In the Drawings:

Please replace drawing sheets 3-4 (showing Figs. 2d-2i) with the newly submitted figures attached herewith on separate sheets.

REMARKS

The Examiner is thanked for the thorough examination of the present application, the allowance of claims 29-32, and the indication that claims 25 and 26 contain allowable subject matter. This response is in response to the Office Action of Sep. 9, 2005.

FIG. 2e

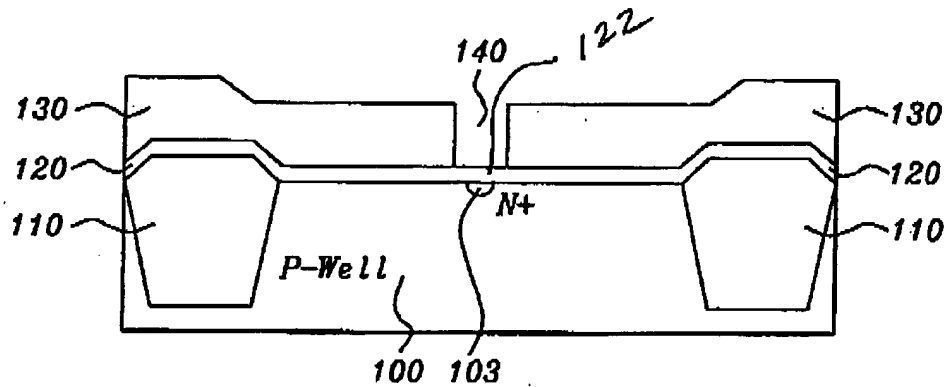
Applicants have amended the specification to change reference numeral 120 to 122, at the bottom of page 14. Applicants also insert, in Figs. 2e-2h, a symbol of 122 to indicate a tunnel oxide and accordingly amends the specification in pertinent part. These amendments add no new matter to the present application.
